TEXAS NATURAL RESOURCE CONSERVATION COMMISSION

November 20, 1998

Re: EDWARDS AQUIFER, Comal County
PROJECT: The Pinnacle Subdivision, Project number 1068, Located on northeast side of Hoffman Lane approximately 6,500 feet from southeast of intersection with FM 306, New Braunfels, Texas
TYPE: Request for Approval of Water Pollution Abatement Plan (WPAP); 30 Texas Administrative Code (TAC) §213.5(b); Edwards Aquifer Protection Program

The Texas Natural Resource Conservation Commission (TNRCC) has completed its review of the WPAP application for the referenced project that was submitted by Pro-Tech Engineering Group, Inc. on behalf of Properties of the Southwest to the San Antonio Regional Office on August 28, 1998. Final review of the WPAP submittal was completed after additional material was received on November 5, 1998 and November 12, 1998. The WPAP proposed in the application is in general compliance with 30 TAC § 213.5(b); therefore, approval of the plan is hereby granted subject to applicable state rules and the conditions in this approval letter. *This approval expires two (2) years from the date of this approval unless, prior to the expiration date, construction has commen

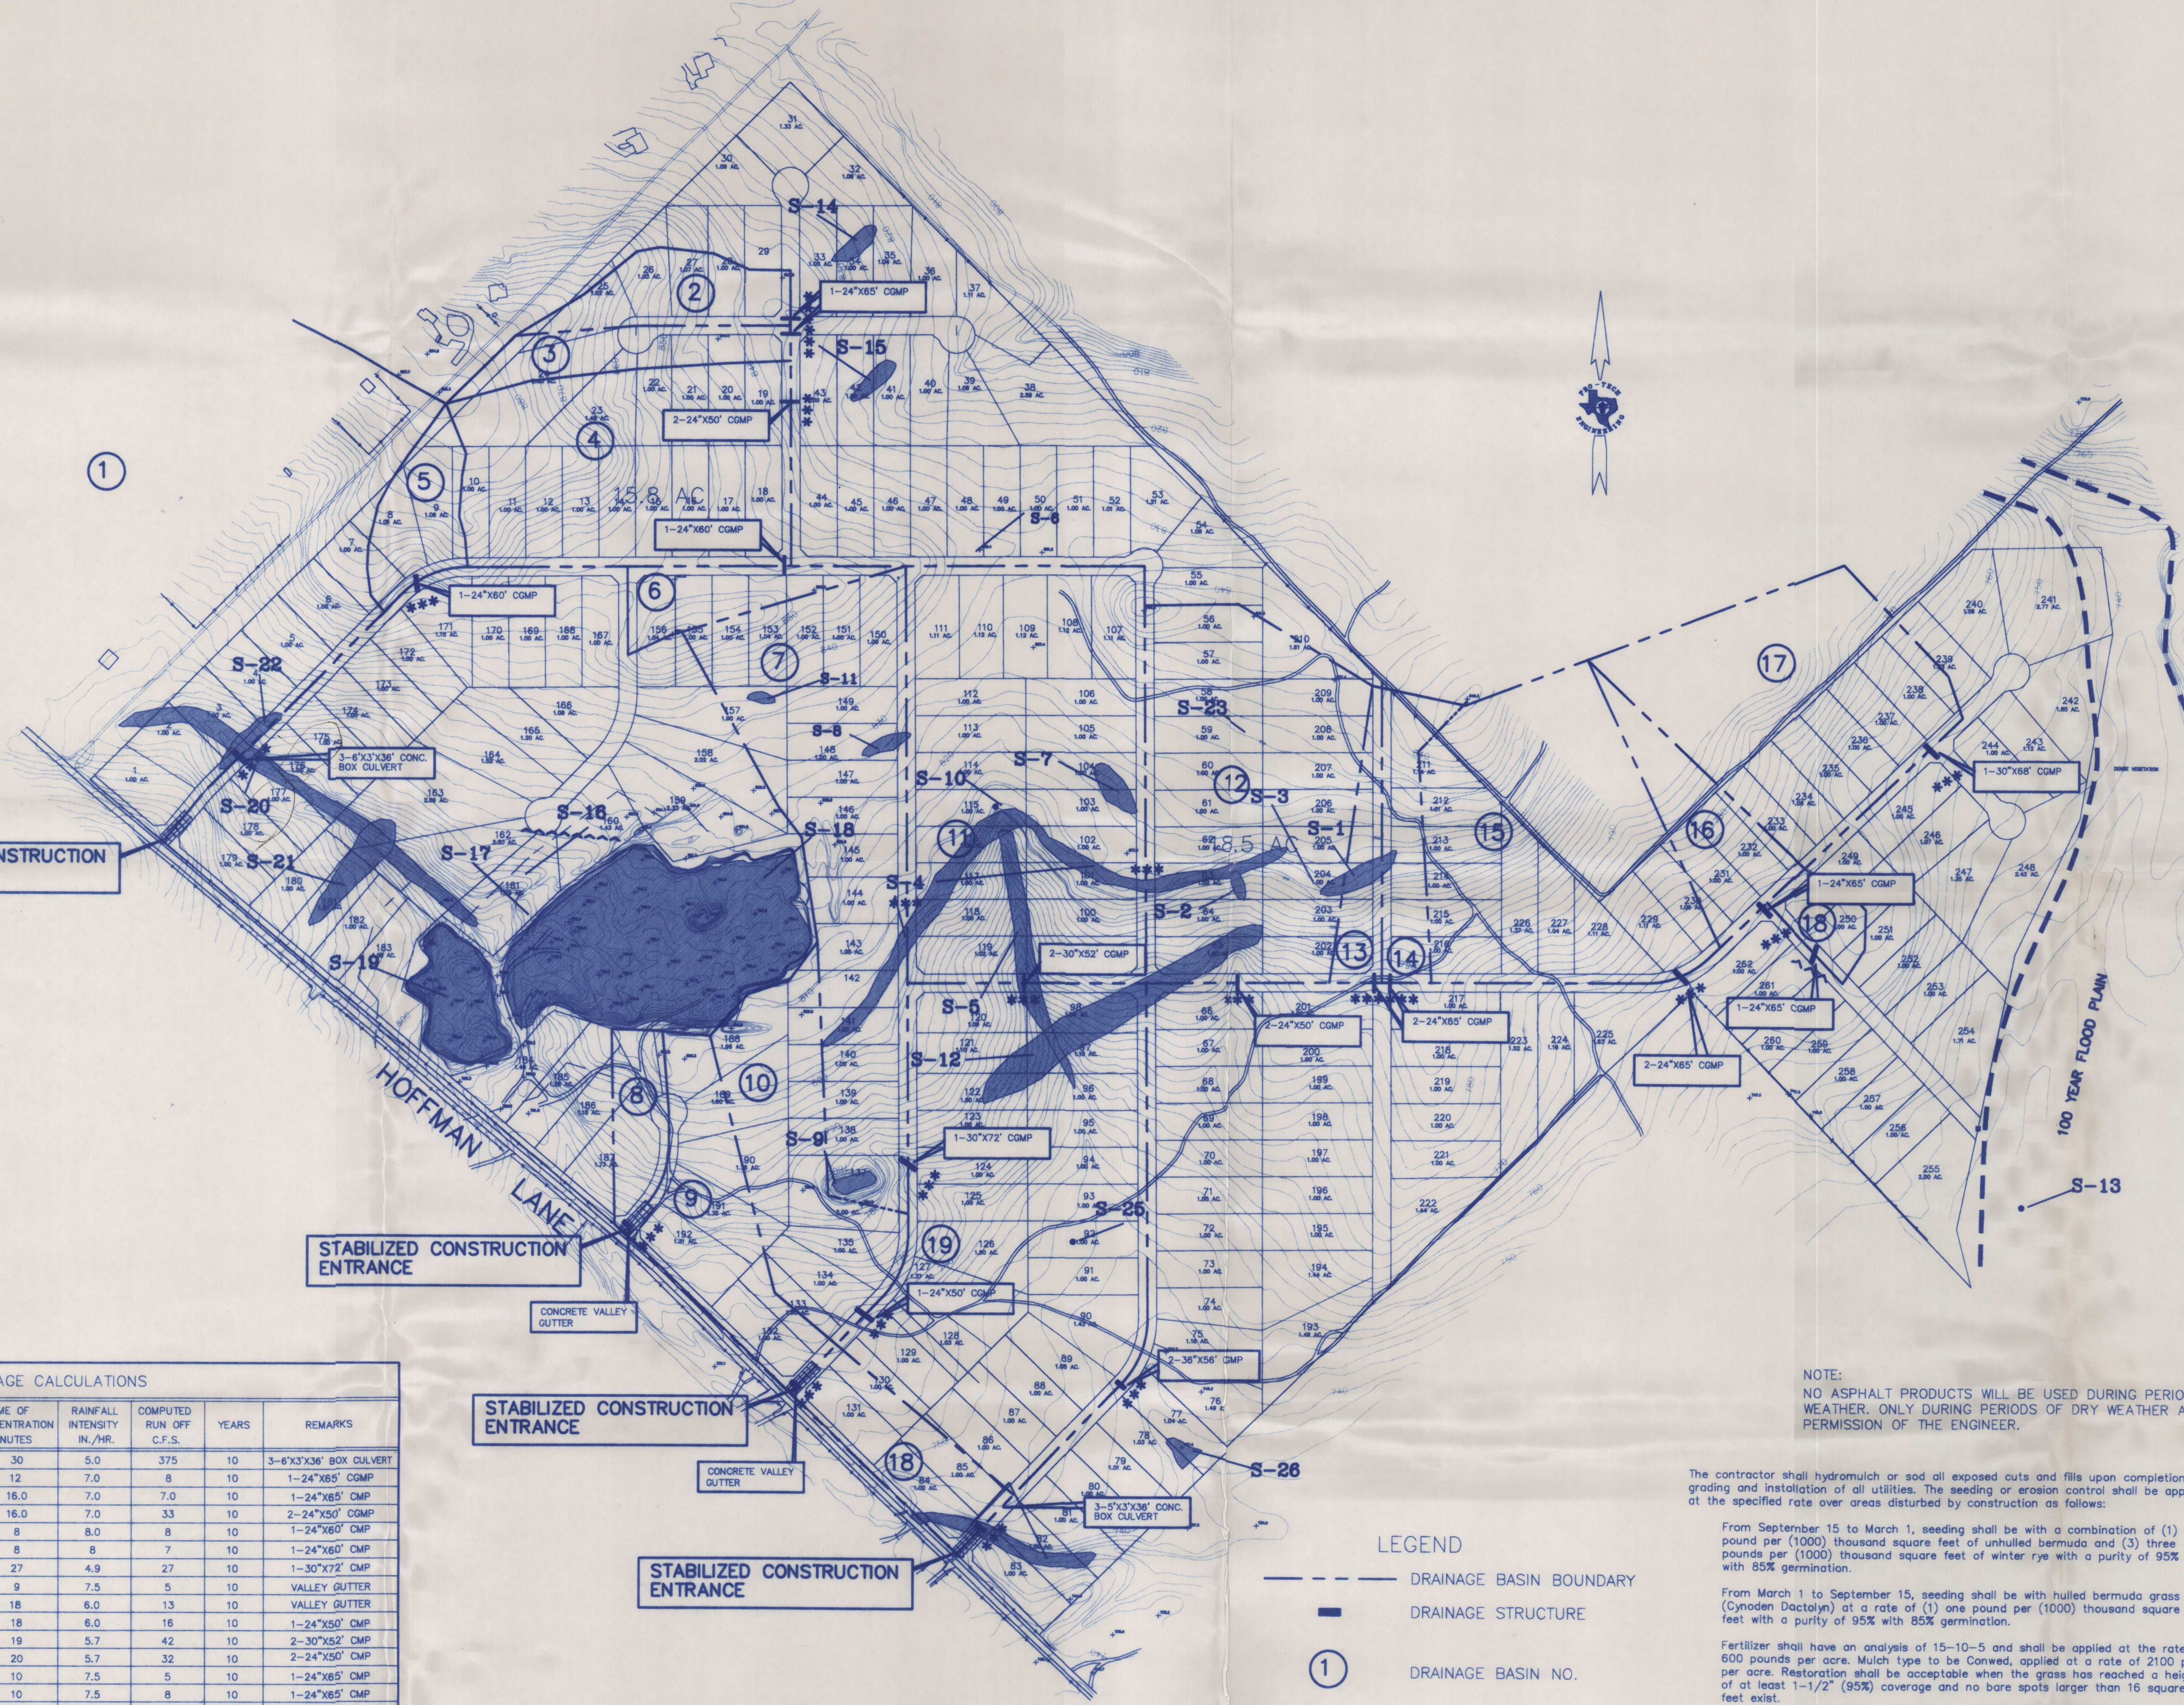
According to the geologic assessment included with the submittal, 26 geologic or manmade features are located on the project site. Seven features were assessed as being sensitive. Fifteen features were assessed as being possibly sensitive. The San Antonio Regional Office site inspection of October 16, 1998, revealed one additional feature not described in the geologic assessment near Lot #148.

2. Feature S-11 on Lot #155 will have a 150 foot radius Sanitary Control Easement.
3. Feature S-12 on Lots #94, 95 and 96 will be filled with 6 inches of clay.

4. Feature S-18, the large quarry, will have a permanent sanitary control easement along the west and north sides of the quarry as shown on the plat submitted to the TNRCC.

5. Feature S-19, the small quarry, will have a permanent sanitary control easement along the west side of the quarry as shown on the plat submitted to the TNRCC.

6. Feature S-20 along the drainage channel will be centered with a 300 foot wide Sanitary Control Easement.
7. Before start of construction of the Park (Feature S-18), the TNRCC will be notified in writing with the source and type of fill materials to be used. The fill material will be tested for metals, pesticides and Total Petroleum Hydrocarbons. Test results will be submitted to the TNRCC for approval before fill material is placed in the Park area.
